The Commission has issued the enclosed Amendment No. 71 to Facility Operating License No. DPR-32 and Amendment No. 71 to Facility Operating License No. DPR-37 for the Surry Power Station, Unit Nos. 1 and 2, respectively. The amendments consist of changes to the Technical Specifications in response to your application transmitted by letter dated May 19, 1981.

AMENDMENT TO FACILITY OPERATING LICENSE

Amendment No. 71  
License No. DPR-32

ATTACHMENT TO LICENSE AMENDMENTS

### ALLOWABLE AIR PARTIAL PRESSURE SURRY POWER STATION

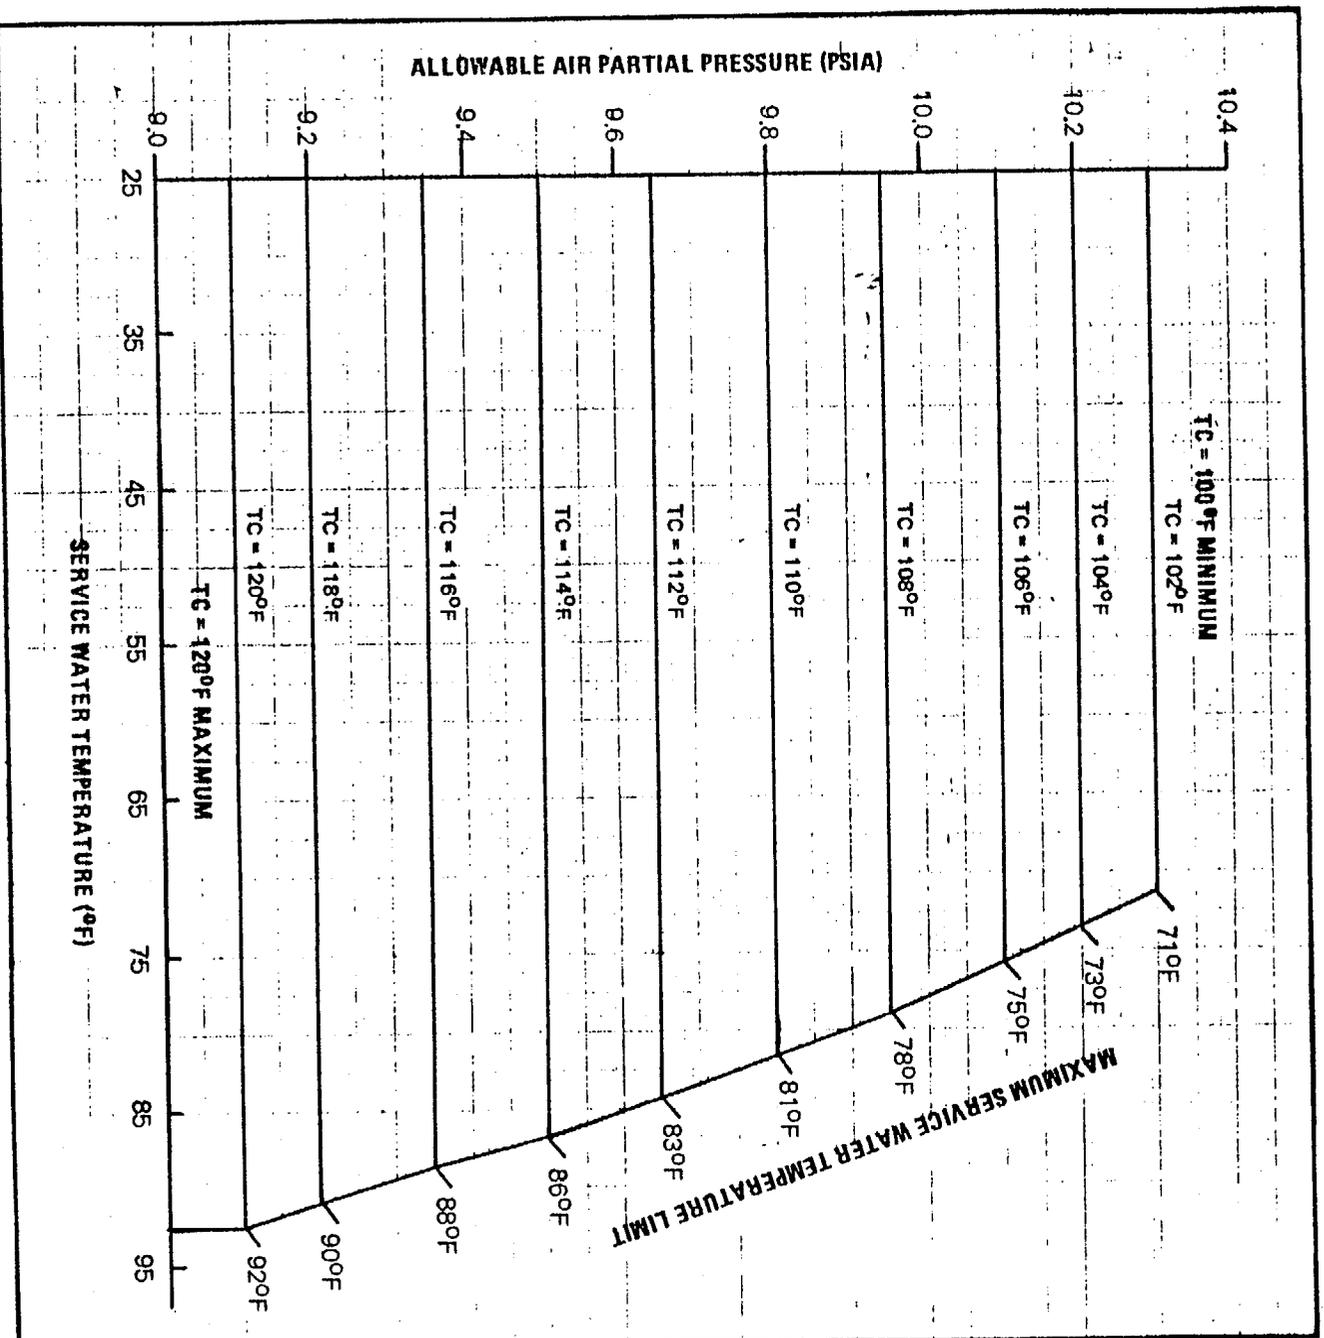
The allowable value for the containment air partial pressure is presented in TS Fig. 3.8-1 for service water temperatures from 25 to 90°F. The allowable value varies as shown in TS Fig. 3.8-1 for a given containment average temperature. The RWST water shall have a maximum temperature of 45°F.

The horizontal limit lines in TS Fig. 3.8-1 are based on LOCA peak calculated pressure criteria, and the sloped line is based on LOCA subatmospheric peak pressure criteria.

1. Allowable operating air partial pressure in the containment as a function of service water temperature.
2. Refueling Water Storage Tank temperature  $\leq 45^{\circ}\text{F}$ .
3. Horizontal lines designate allowable air partial pressure setpoint per given containment average temperature.
4. Each containment temperature line is a maximum for the given air partial pressure.
5. Hot shutdown is required for containment air partial pressure increase greater than 0.25 psi above the allowable value or less than 9.0 psia.
6. Cold shutdown is required for containment air partial pressure less than 8.25 psia.
